# UNITED STATES PATENT AND TRADEMARK OFFICE

APPLICATION NO.	FILING DATE	FIRST NAMED INVENTOR	ATTORNEY DOCKET NO.	CONFIRMATION NO.
10/584,779	02/03/2009	Thomas Scherer	WUE-51	4949
26875 7590 01/31/2011 WOOD, HERRON & EVANS, LLP 2700 CAREW TOWER 441 VINE STREET CINCINNATI, OH 45202				
EXAMINER DUKE, EMMANUEL E				
ART UNIT		PAPER NUMBER		
3784				
MAIL DATE		DELIVERY MODE		
01/31/2011		PAPER

# Office Action Summary

Annotated FIG. 8

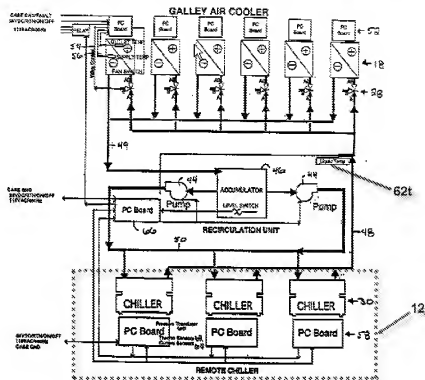
Regarding claim 1, Simadiris et al. '361 disclose a cooling system for the cooling of heat producing devices in an aircraft (Fig. 6-8: [0023]), comprising: a cold producing device (see annotated Fig. 8: [0043-0044], wherein 12 constitutes a cold producing device) including at least two cooling machines (Fig. 8: [0043-0044], wherein chiller 30

constitutes a cooling machines) working independently of each other (as shown in Fig. 6-7: wherein the chillers for Door 2 are depicted independently operating from the chillers of Door 4), at least one cold consumer (Fig. 8: [0032], wherein a galley air cooling unit 18 constitute a cold consumer), and a cold conveyance system (Fig. 1-2: [0036-0037], wherein a recirculation/redistribution unit 32 constitute a cold conveyance system) which connects the cold producing device and the at least one cold consumer, whereby the cold conveyance system including at least two cooling circuits completely independent of each other (as shown in Fig. 6-7: wherein the RU 32 for Door 2 are depicted independently operating from the RU 32 of Door 4), the at least two cooling, circuits (48, 49, Fig. 8: [0045]) supplying a cold carrier medium (27, Fig. 8: [0045]) that has been cooled by the cold producing device to the at least one cold consumer and returning the cold carrier medium from the at least one cold consumer to the cold producing device, whereby the at least two cooling machines are coupled in parallel to the cold conveyance system (as shown in Fig. 4: wherein in Door 2, two RC 30 are couple in parallel to the RU 32) such that each of the at least two cooling circuits are thermally coupled (as shown in Fig. 4: wherein in Door 2, lines 48 and 49 are shown thermally coupled) to the at least two cooling machines.

Regarding claim 9, Simadiris et al. '361 disclose the cooling system in accordance with claim 8, wherein at least two cold carrier pumps (as shown in Fig. 8: wherein two cold carrier pumps 44) are assigned to cooling circuit and are supplied with electric energy (Fig. 8: [0049], wherein a control device 66 associated with each RC 32 supplies electric energy) independently of one another.

Regarding claim 13, Simadiris et al. '361 disclose the cooling system in accordance with claim 1, further comprising a central control unit (58, Fig. 8: [0009], [0048]) configured to control the cold output of each of the at least two cooling circuits, dependent upon at least one of the specified parameters ([0050], wherein a 30° F is one of the specified parameters) for a current cold requirement.

Regarding claim 18 Simadiris et al. '361 disclose the cooling system in accordance with claim 13, wherein the central control unit records an output (see annotated Fig. 8: wherein in liquid temp 62t constitutes an outlet) temperature of the cold carrier medium leaving the at least two cooling machines and controls the at least two cooling machines in accordance [0049] with the output temperature measured and recorded.
